BUS STATION SUBGROUP

RESPONSE TO CITY OF YORK COUNCIL'S ANALYSIS OF YBF BUS INTERCHANGE PROPOSALS

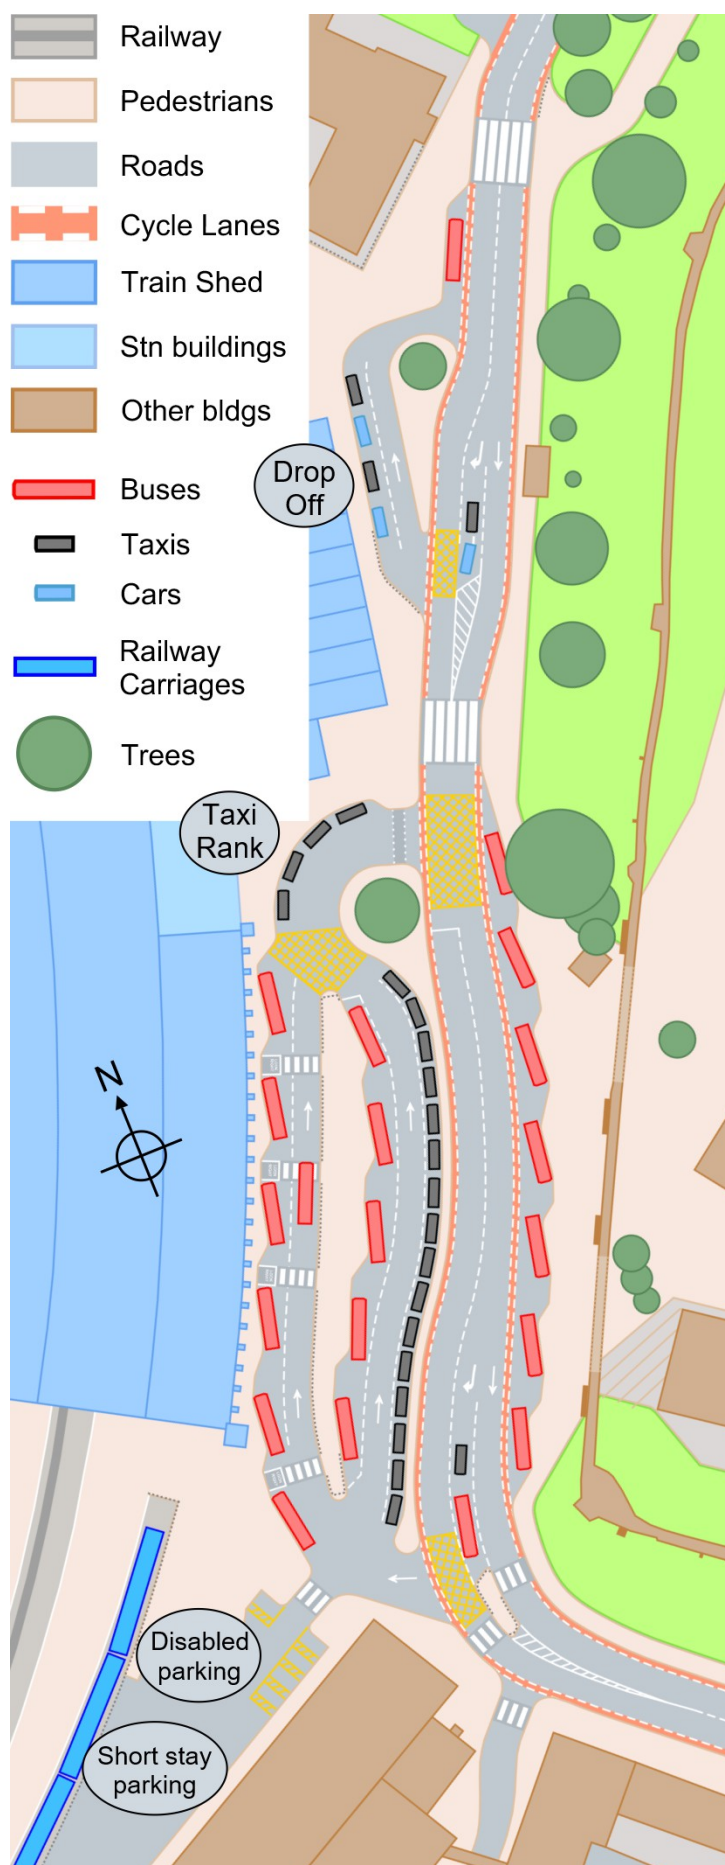
Although the excellent access to the railway station provided by the previous proposal cannot be achieved for southbound bus users, it is largely retained for passengers of northbound and terminating services.

The location of the taxi queue and drop-off in the CYC proposal puts a barrier between the buses and the railway station. This proposal removes that objection by relocating the queue and drop-off, as did the original proposal.

Taxi Rank

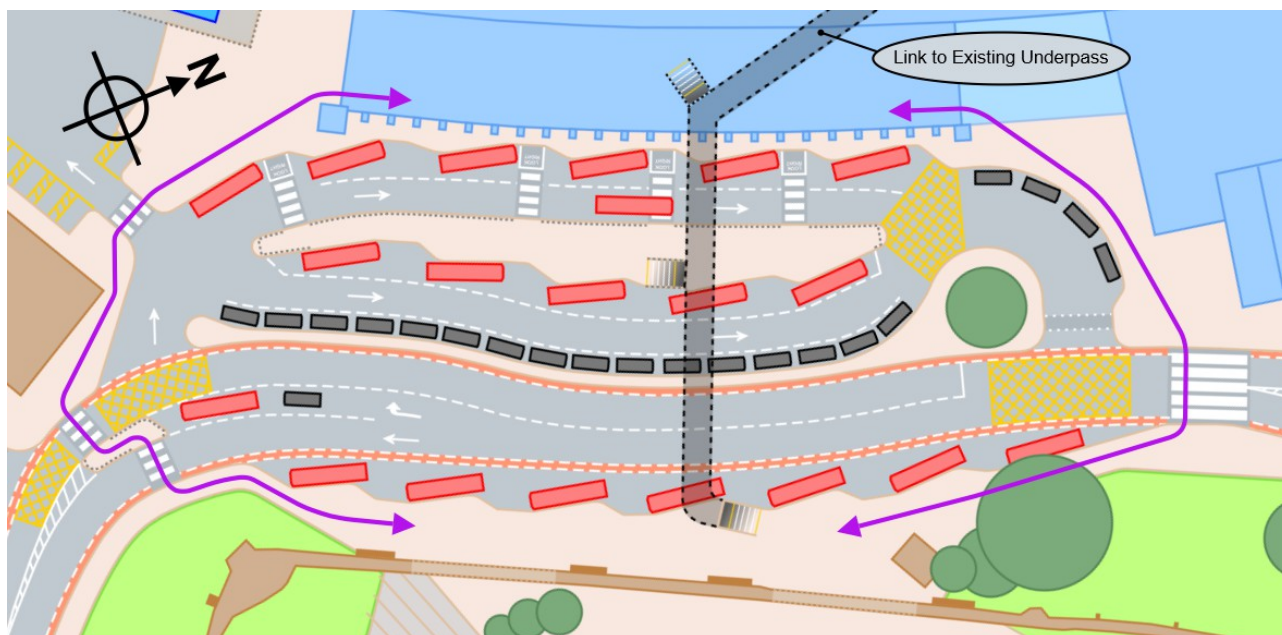
The location of the taxi rank and queue is carried over from the YBF1 proposal to this modified proposal, as the map below shows. Its merits are unchanged.

A key feature is that although the taxi rank is adjacent to the station, the waiting queue is not, so it doesn't form a barrier between buses and the railway station as it does in the CYC proposal.

An Underpass?

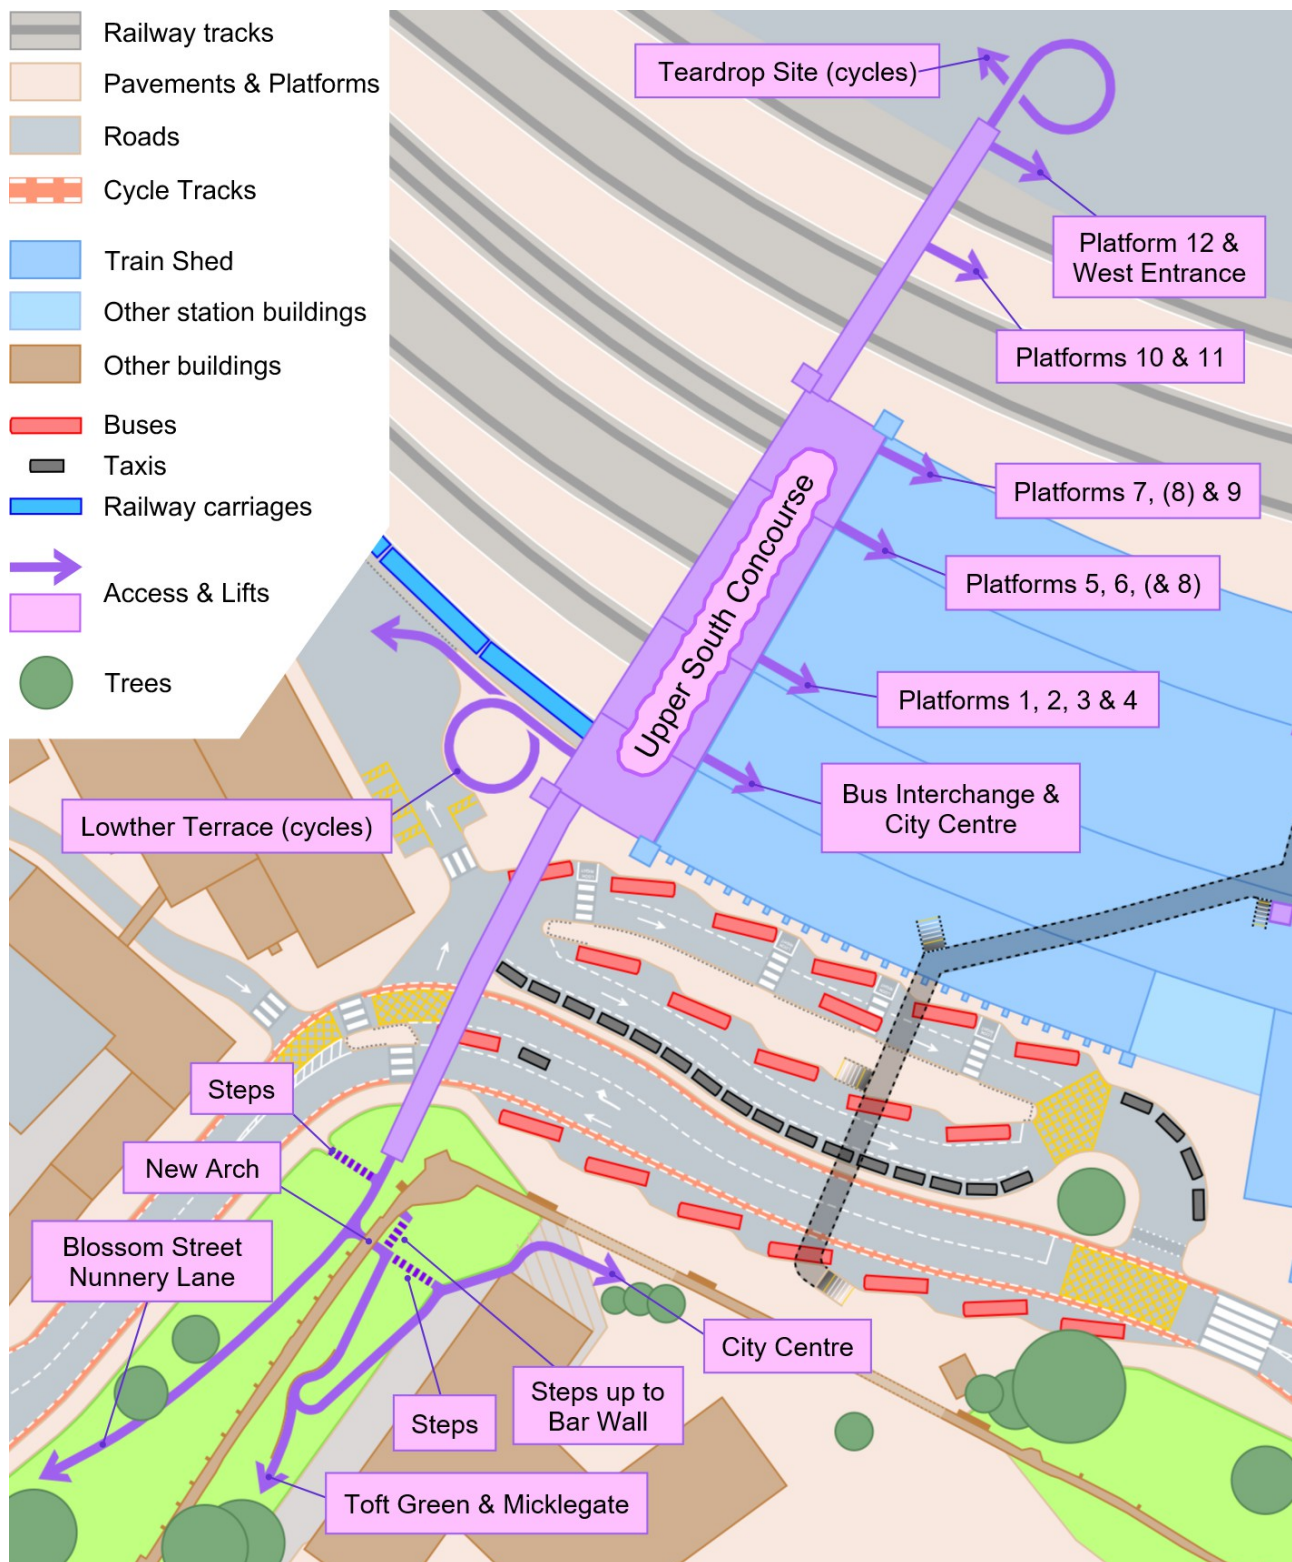
The purple arrows in this map illustrate a problem: putting straight-through bus stops on opposite sides of the road can make the walking route from one side to the other rather too long. The number of people changing from one bus in one direction to another in the other direction will presumably be small, but the connection between the southbound bus stops and the railway station could be better, and preferably under shelter. The absence of a more direct route would encourage jaywalking.

In terms of walking distance, the CYC Station Front consultation proposal is even worse because people are expected to use the splendid new crossing further north at the middle of the Portico, which is (despite CYC claims to the contrary) a loss of amenity for bus users.

The suggestion here is an underpass roughly across the middle of the development, as shown. The entrances are between buses, at points where no bus doors are obstructed, even if buses with centre doors are used.

The question of disabled access to the underpass inevitably arises. No solution is offered here because ramps would need to be of the order of 30 to 40 metres long, or lifts provided. Inside the train shed this should be possible, but near the bar walls it isn't clear how to provide such ramps in a sympathetic way. Disabled access to the island is not needed because it can be reached from inside the train shed, using the pedestrian crossings. Answers on a postcard, please!

Appendix D - Diversion of Road during Bridge Demolition

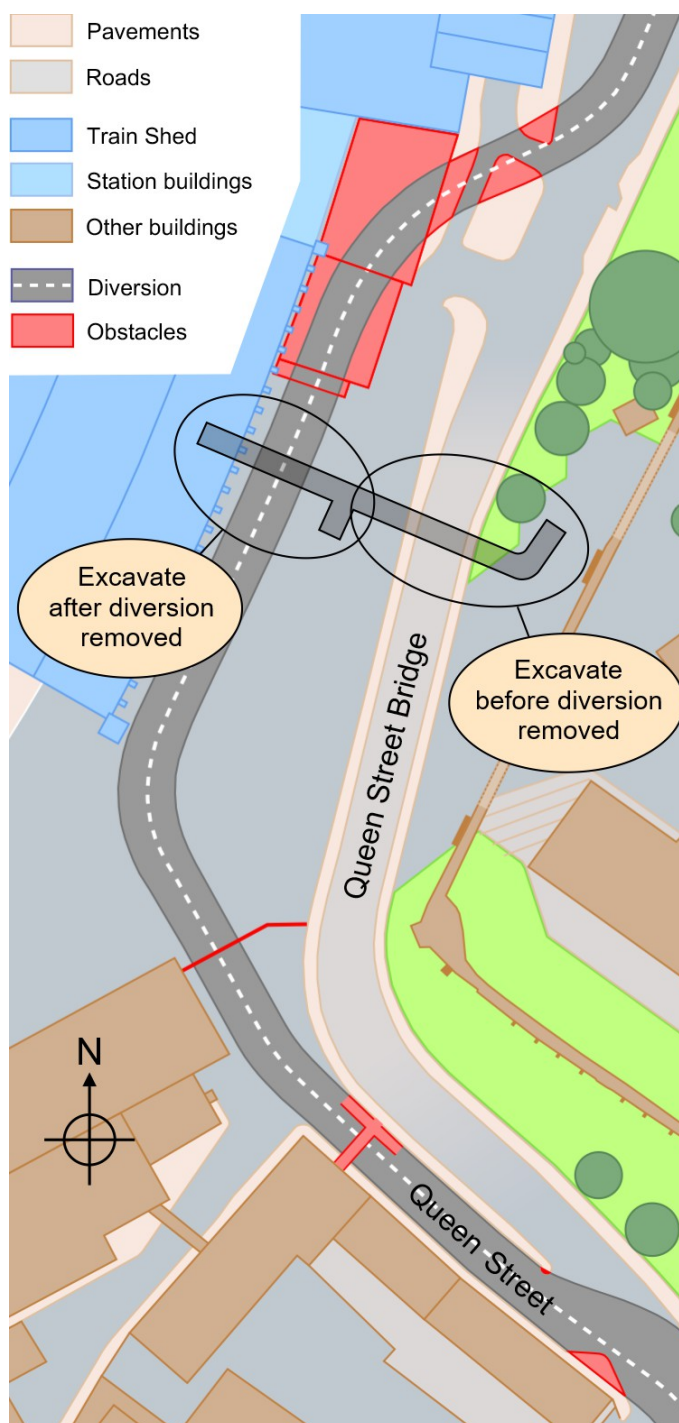
This section addresses objections on the grounds that demolishing Queen Street Bridge would be far too disruptive, or that diversionary arrangements would be too expensive. Knocking the bridge down would be no trivial task. Naturally enough, fears arise that doing so could cause horrendous disruption. It would be idiotic to pretend disruption can be avoided, but the worst – closing this part of the ring road – should not be necessary.

With the steps and bridge up to the Railway Institute first floor fire exit removed, and a parking ban, Queen Street looks wide enough to take two-way traffic.

The entrance to the long-stay car park is more than wide enough to take two-way traffic, with the demolition of station extensions due to be removed anyway, a bit of pavement and some railings.
